City of Round Rock

Planning and Zoning Commission

Meeting Agenda - Final

Wednesday, April 19, 2017

**The Depot Townhomes Phase 3
FINAL PLAT FP1704-003**

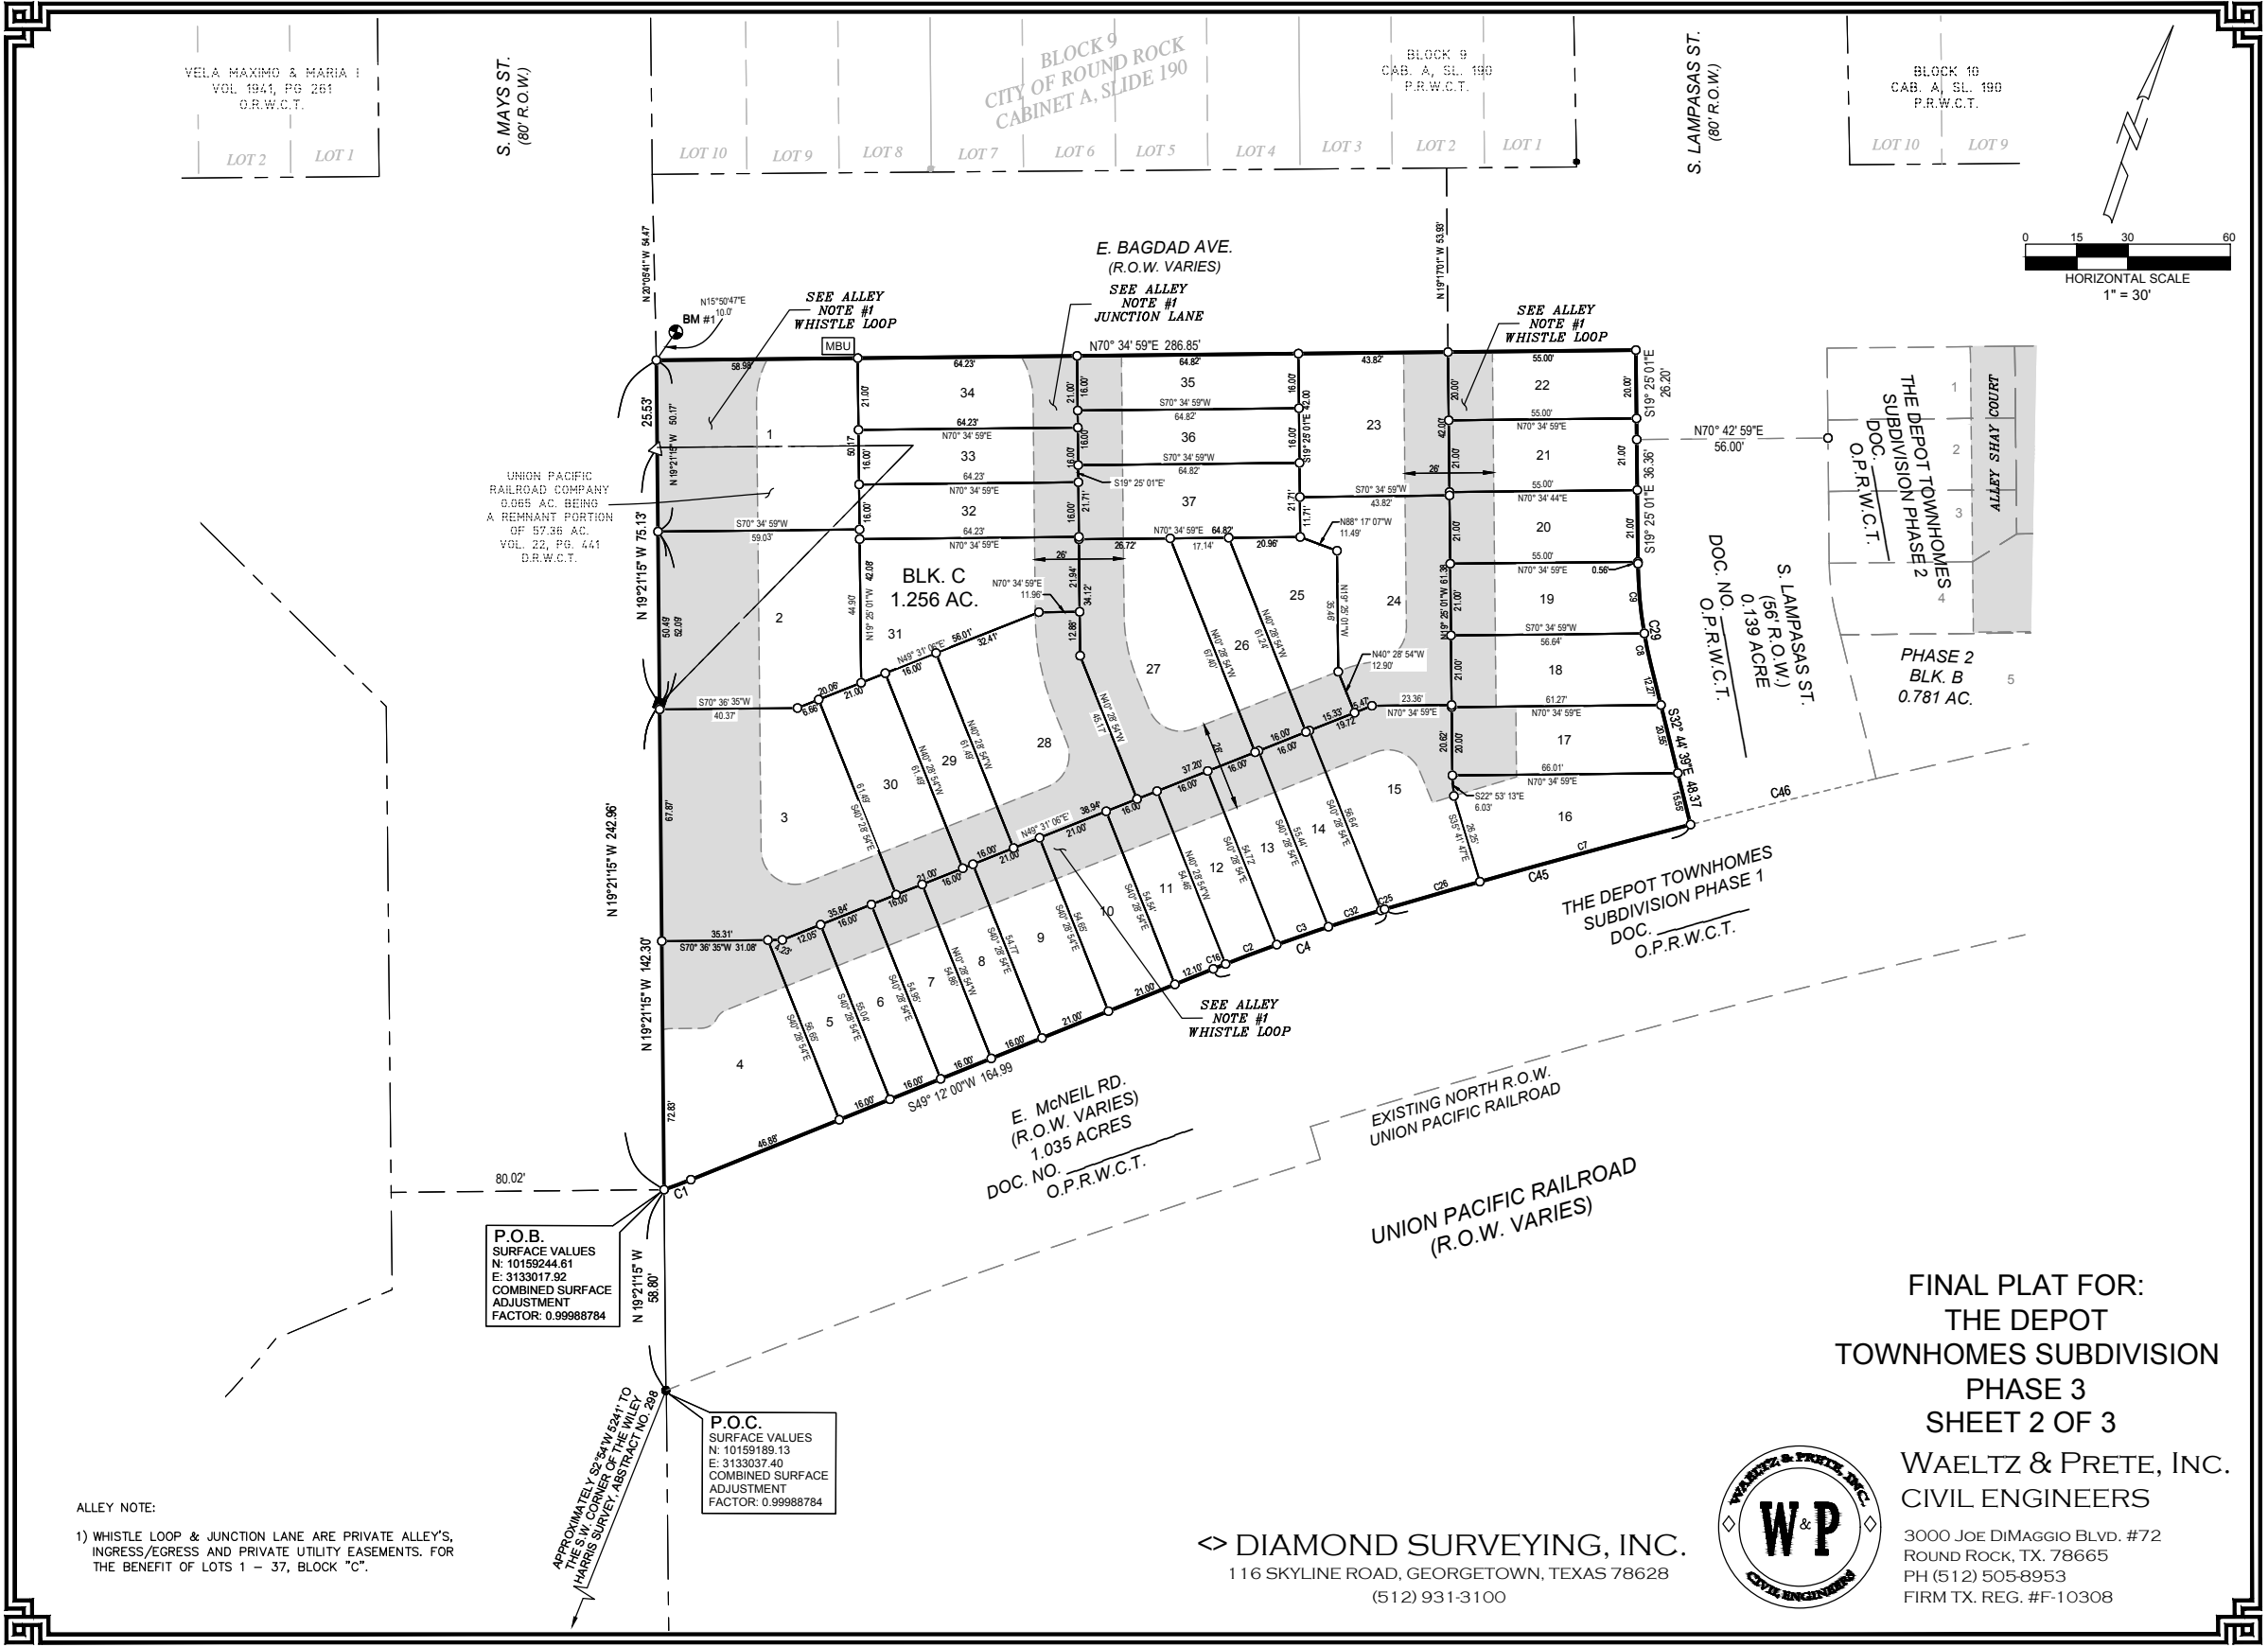
The Union Pacific Railroad currently owns a small triangular piece of the block that is proposed for phase 3. The developer is currently in negotiations to acquire this area, which is the only part of the assemblage not under City of Round Rock ownership. The plat currently contains a signature block for the railroad. The railroad's signature would not be needed at recordation if the land has been transferred to the developer by that time. If the negotiations fail and the land is not transferred, the plat would be revised prior to recordation to omit the railroad's property.

- 1) Approval contingent upon City Council approval of PUD 110.
- 2) Fill in all PUD and document numbers left blank in current submittal.
- 3) Change Note #3 to the following: This final plat conforms to the preliminary plat as approved by the Planning and Zoning Commission on April 19, 2017.
- 4) Change Note # 4 to the following: No unit shall take direct driveway access to any public right of-way.
- 5) Prior to or in tandem with final plat recordation, an Ingress and Egress Easement to the City to traverse alley areas shall be recorded.
- 6) Remove "alley" prefix from Shay court depicted in section 2.
